**From:** Turchy, Michael A  
**Sent:** Monday, July 7, 2025 10:05 AM  
**To:** Annino, Amy; Jamison, John  
**Cc:** Amschler, Crystal C CIV USARMY CESAW (US); McHenry, David G; Wojski, Paul A; Pjetraj, Michael; Bukowy (HNTB), Kat A  
**Subject:** RE: Request for Additional Information: DWR 20250109 V3 - Hurricane Helene I-40 Pigeon River Gorge Emergency Relief Project

**Subject:** Request for Additional Information: DWR 20250109 V3 - Hurricane Helene I-40 Pigeon River Gorge Emergency Relief Project

# TIP PROJECT: I-40 PIGEON RIVER

**S-006R3: REVISED PERMIT DRAWINGS**  
**DATE: 06/03/2025**

### WETLAND AND SURFACE WATER IMPACTS SUMMARY

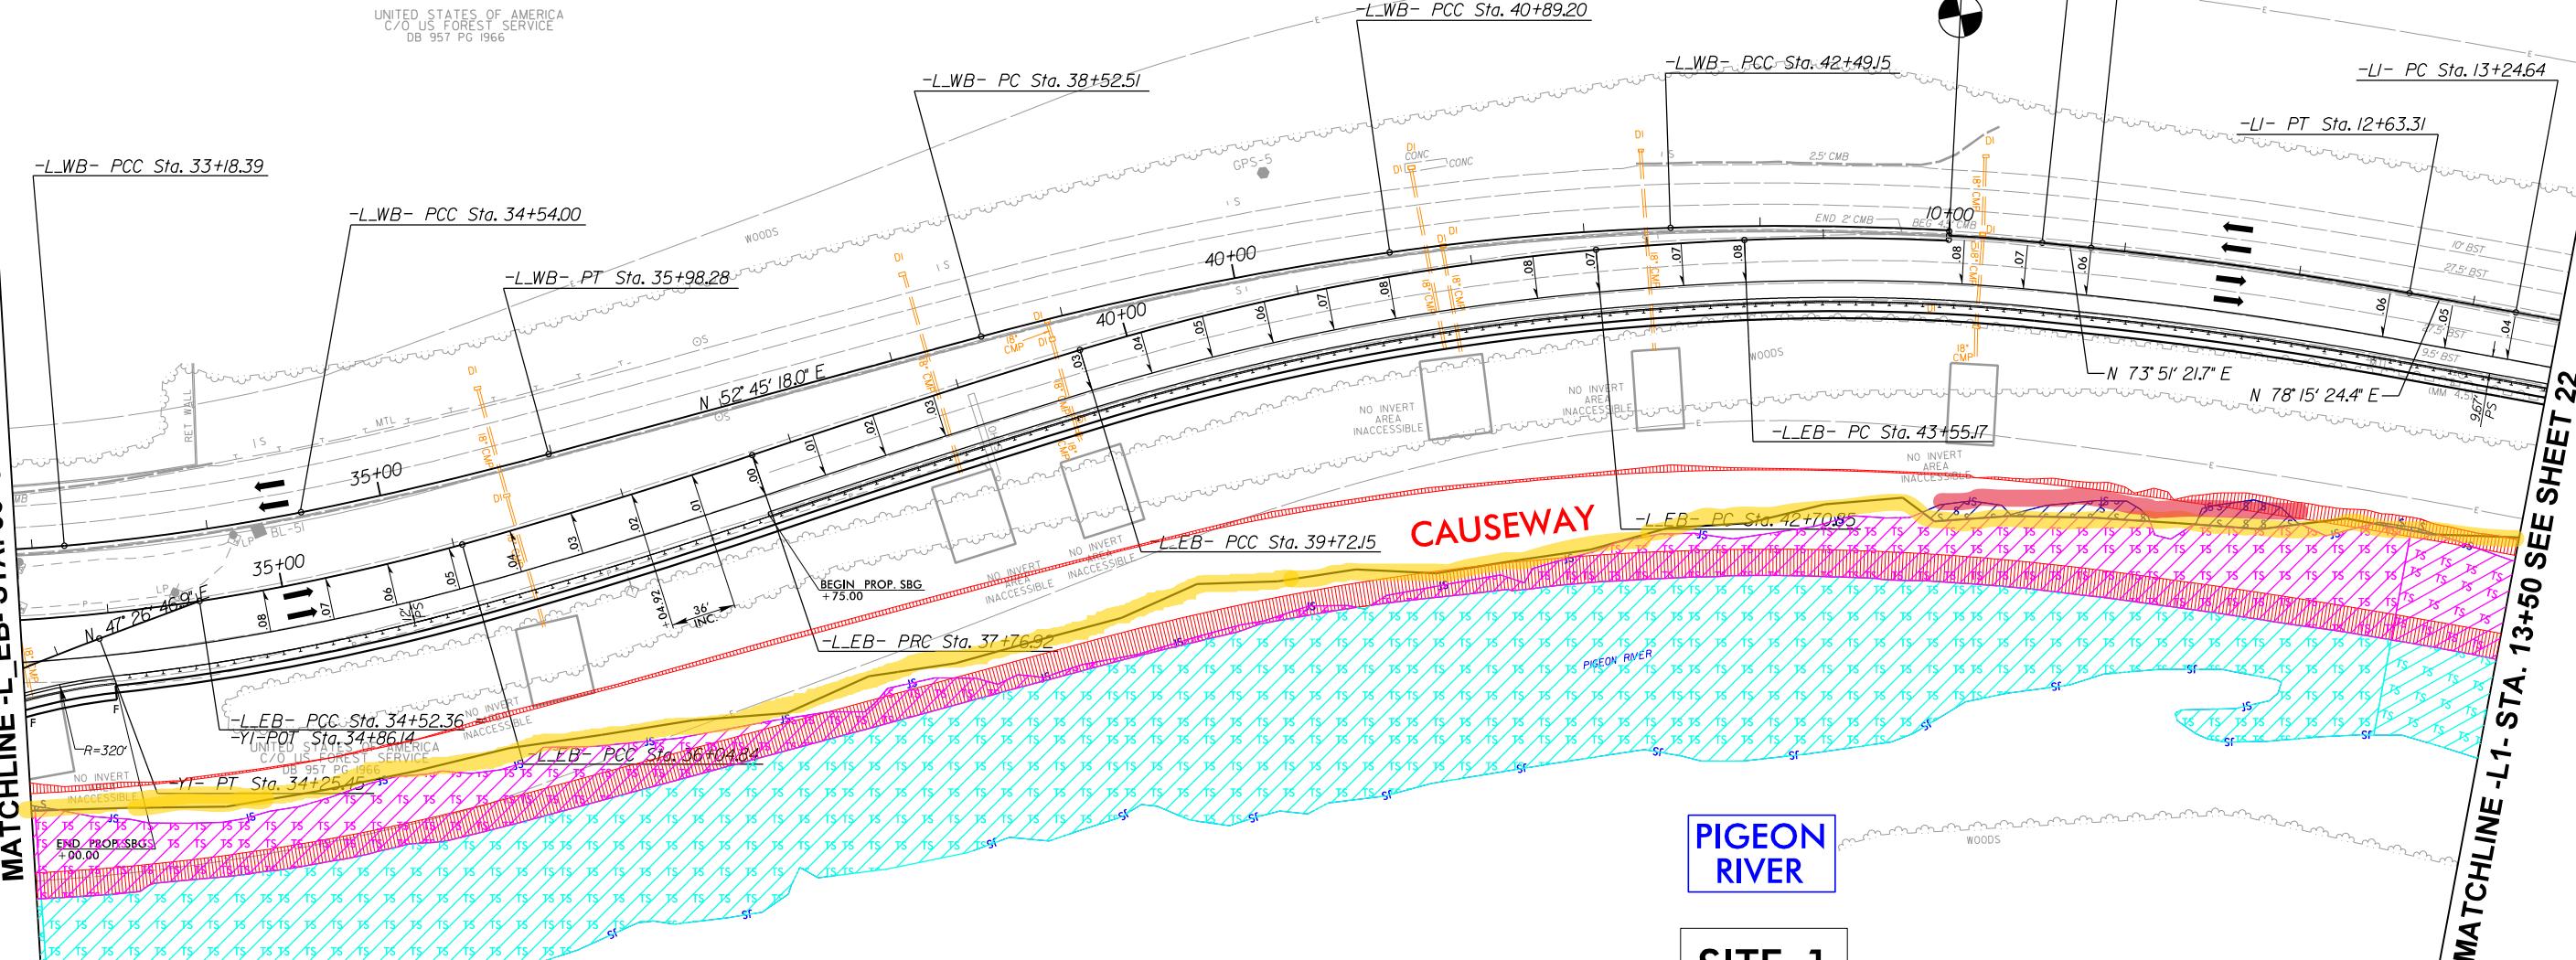
3. Please show the footprint of the proposed retaining wall through the project area

The proposed wall is located on the submitted set of drawings, and attached is a marked up set of drawings highlighting the wall for clarity, titled “**Drawings with Wall Highlighted**.”

The wall is highlighted in yellow. Wall impacts are highlighted in red.

Additionally, the impact summary table has been excerpted on each page to clarify the quantify the wall impact.

As previously noted, impacts are shown using the “scour zone limits” of the Pigeon River, as locating the ordinary high water mark post-Helene is not possible. Therefore, these drawings display a “worst case scenario” and are likely much lower than indicated.

The total proposed wall impacts to the Pigeon River are 12,116 linear feet.
